MIPS R4400PC/SC Errata, Processor Revision 1.0

February 9, 1994

Figure 1a: Power-on Reset or Cold Reset - Workaround for Bug# 22

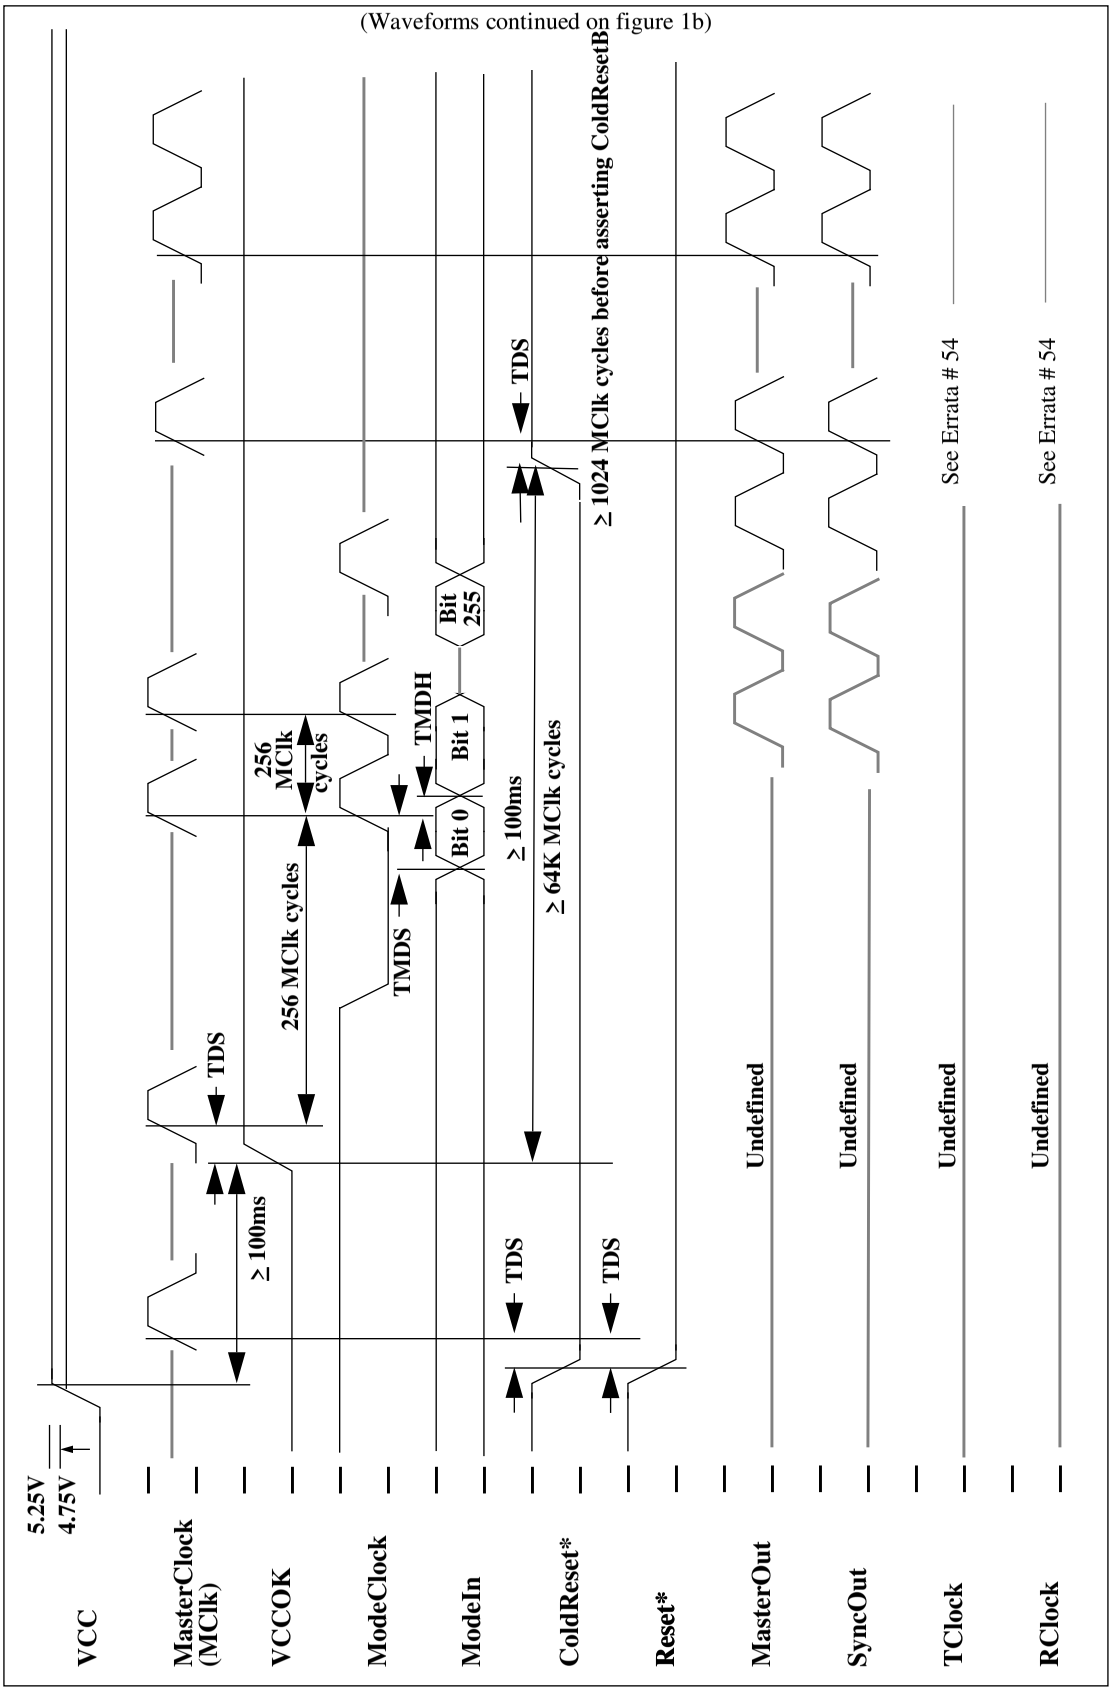
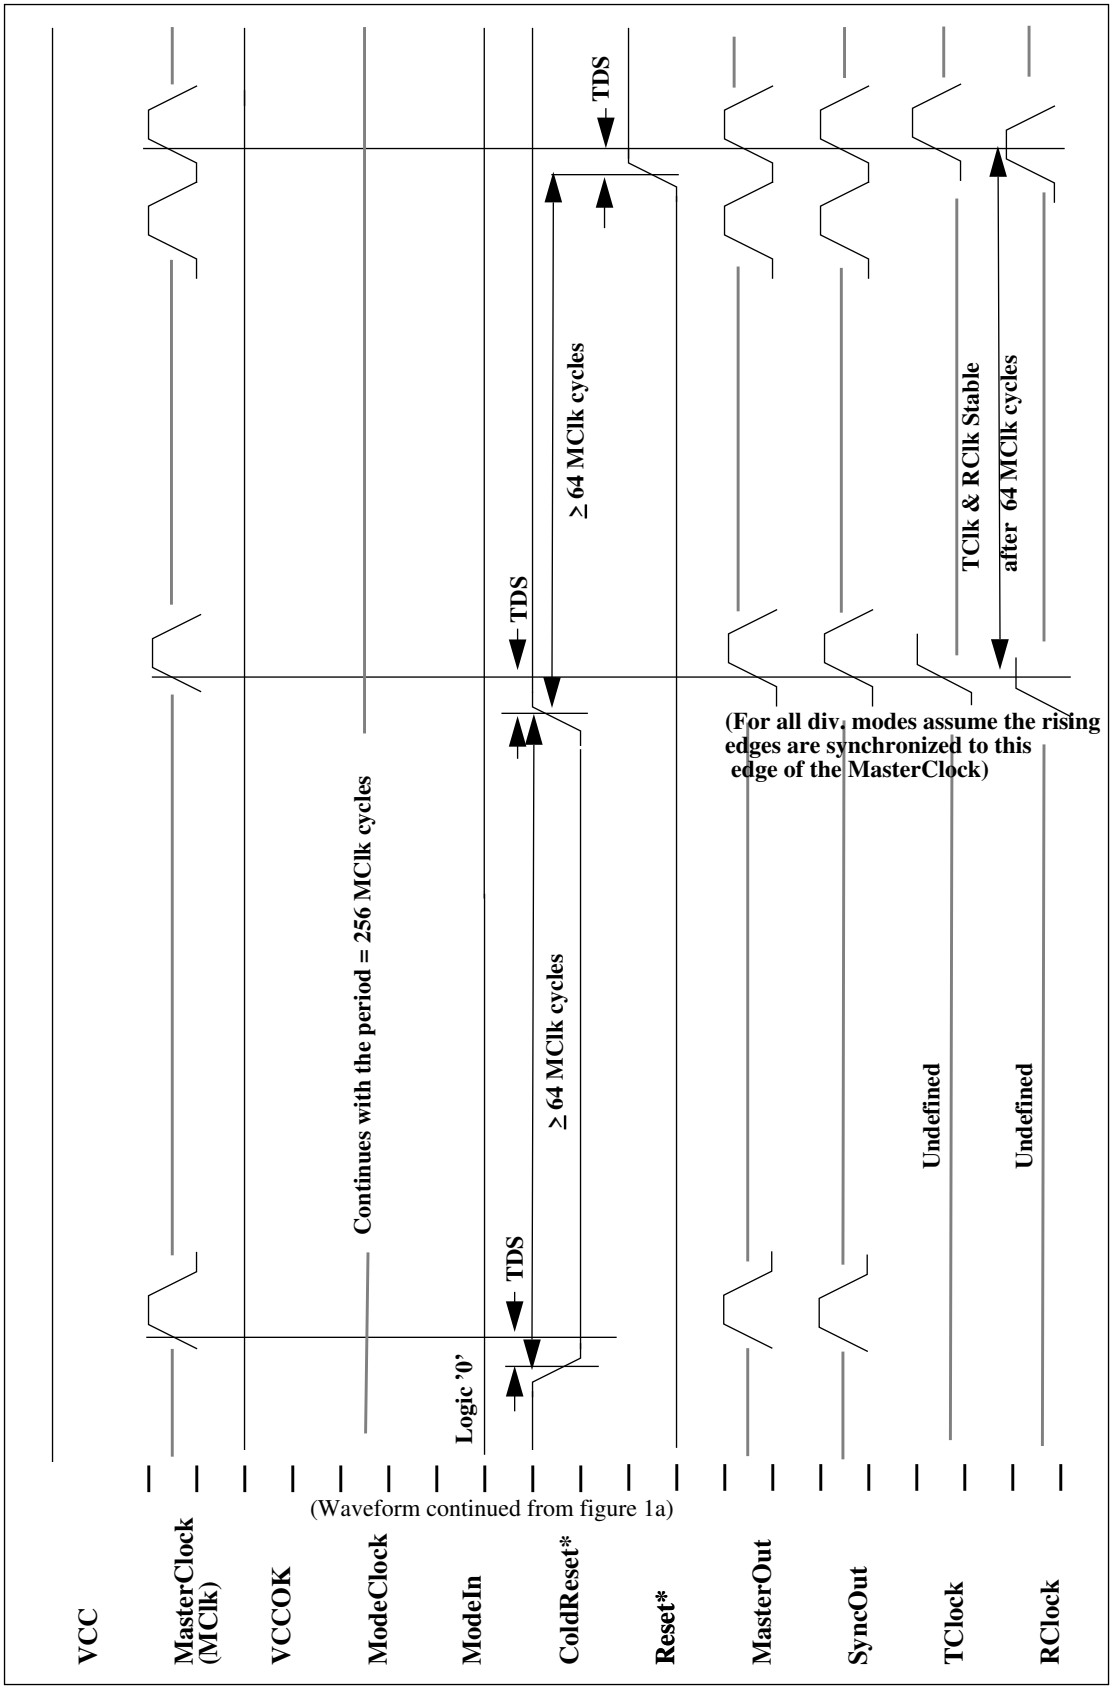
22. R4400PC, R4400SC: During the power up sequence, the period of TClk and RClk may not be as expected for at least 1024 MasterClock cycles following the de-assertion of ColdResetB. The above bug is true for all system interface divisors. Furthermore, if the system interface divisor other than 2 (i.e. 3,4,6 & 8) is used, TClk and RClk's rising edge may not align to the rising edge of the MasterClock, as specified.

this bug may cause problems.
Thus, for system with interface divisor set to two, the only violation will be that the TClk and RClk's period might not be valid within 64 MasterClock after the ColdResetB is de-asserted.

Workaround:Assert a second ColdResetB after at least 1024 MasterClock cycles from the de-assertion of the first ColdResetB. ResetB should remain asserted until at least 64 MasterClock cycles following the de-assertion of the second ColdResetB. TClk and RClk will then be valid 64 MasterClock cycles after the de-assertion of the second ColdResetB and their edge alignment with respect to MasterClock will be as specified. Figure 1a & 1b show the waveforms in more detail. Note that the waveforms in Figure 1b are continuation of the those in figure 1a.
